DEPARTMENT OF THE INTERIOR

Bureau of Land Management

Onshore Oil and Gas Operations; Federal and Indian Oil and Gas Leases; Measurement of Gas

ACTION: Final rule.

Figure 2

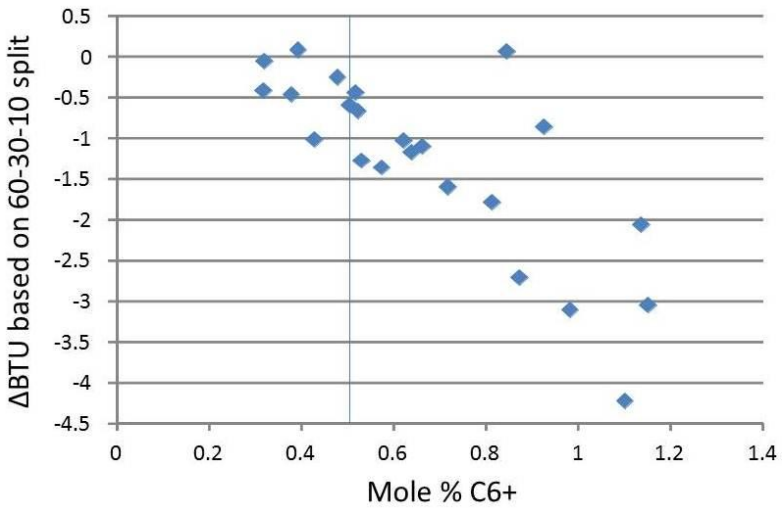
One commenter indicated that the difference in heating value between a C_6+ analysis and an extended analysis is less than the accuracy of the GC, and therefore, is not significant. Several commenters submitted data showing the difference in heating value based on a C_6+ analysis and an extended analysis. The BLM analyzed these data and generated a graph showing the difference in heating value between a C_6+ analysis and an extended analysis as a function of the mole percentage of C_6+, assuming a 60-30-10 split of hexane, heptane, and octane, respectively (Figure 2).

The BLM does not believe that Figure 2, generated from the data supplied by the commenters, supports the commenter's conclusions that the difference between an extended analysis and a C_6+ analysis is less than the accuracy of a GC and is not significant or necessary. To analyze these data, the BLM first determined whether the apparent bias in the data as the mole percent of C_6+ increases is statistically significant. To do this, the BLM used the reproducibility column from Table VI of GPA 2261-13, which gives an indication of the amount of deviation a given component will exhibit

Because this analysis compares data points to each other, the uncertainty of both data sets "a" and "b" is ±2 Btu/scf, which yields a threshold of significance of ±2.8 Btu/scf. In other words, any difference between two data points that is greater than ±2.8 Btu/scf is statistically significant, and is outside the uncertainty associated with the gas chromatograph that derived these data points. From Figure 2, there are three points that fall outside of the ±2.8 Btu/scf threshold at the bottom right-hand part of the graph. These three points include three of the four highest mole percentages of C_6+ included in the data (1.0, 1.1, and 1.15 mole percent C_6+). As a result, the BLM concludes that the data presented by the commenters indicates a statistically significant bias associated with the assumed 60-30-10 split of C_6+ when the mole percent of C_6+ is 1.0 mole percent or higher. Therefore, the BLM disagrees with the comment that the difference in heating

The BLM notes that Figure 2 is based on one data set that contains a fairly narrow range of heating values (1,086 Btu/scf to 1,181 Btu/scf) and, as such, may not be representative of potential bias or correlations that exist outside of that heating value range. Based on the threshold of significance analysis describe above, the BLM agrees that the 0.25 mole percent threshold from the proposed rule is too low and most likely would be less than the uncertainty of most GCs. However, the BLM believes that a threshold of 1 mole percent of C_6+ is too high because the evidence supplied by one of the commenters (Figure 2) demonstrates that statistically significant bias is already present when the mole percent of C_6+ reaches 1 percent. As a result, the BLM raised the threshold to 0.5 mole percent of C_6+, which is one of the thresholds suggested by a

Figure 3

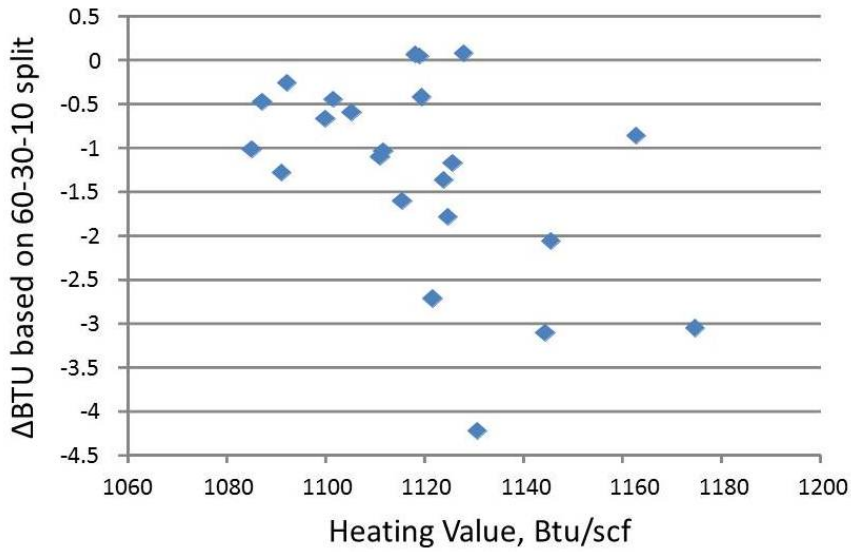
One commenter suggested basing the threshold on the Btu content in combination with the mole percentage of C_6+. The BLM analyzed the suggestion of basing the threshold on the Btu content rather than on the mole percentage of C_6+. Figure 3 shows the same data as in Figure 2, but plotted against heating value instead of the mole percentage of C_6+. Based on an analysis of Figure 3, the BLM believes the relationship between heating value difference and heating value (correlation coefficient of 0.24) is much less clear than the relationship between heating value difference and concentration of C_6+; therefore, the BLM did not adopt the suggestion to base the threshold on heating value.
